PIC16C73

PIC16C73 Rev. A Silicon Errata Sheet

The PIC16C73 (Rev. A) parts you have received conform functionally to the Device Data Sheet (DS30390E), except for the anomalies described below.

Clarifications/Corrections to the Data Sheet:

FIGURE 1: WRITES TO TIMER1 (EXTERNAL CLOCK / OSCILLATOR MODE)

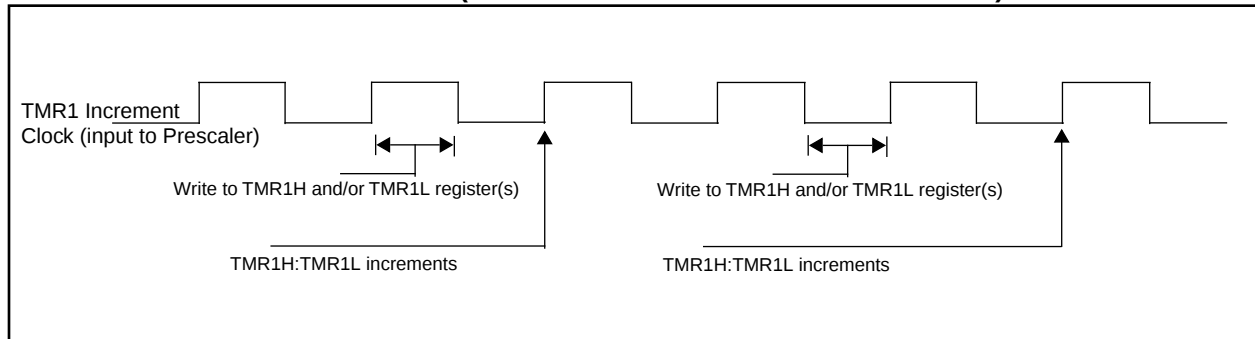
- a) The operation of Timer1 needs some clarification when the timer registers are written when the TMR1ON bit is set.

The internal clock signal that is the input to the TMR1 prescaler affects the incrementing of Timer1 (TMR1H:TMR1L registers and the Timer1 prescaler). When the Timer1 registers are NOT written, the Timer1 will increment on the rising edge of the TMR1 increment clock.

When the TMR1H and/or TMR1L registers are written while this clock is high, TMR1 will increment on the next rising edge of this clock.

When the TMR1H and/or TMR1L registers are written while this clock is low, TMR1 will not increment on the next rising edge of this clock, but must first have a falling clock and the rising clock for TMR1 to increment.

Figure 1 shows the two cases of writes to the TMR1H and/or TMR1L registers. Due to the V_{IH} and V_{IL} thresholds on the oscillator/clock pins, external Timer1 oscillator components, and external clock frequency, the Timer1 increment clock may not be of a 50% duty cycle.

The TMR1 increment clock is out of phase of the T1OSO/T1CKI pin by a small propagation delay.
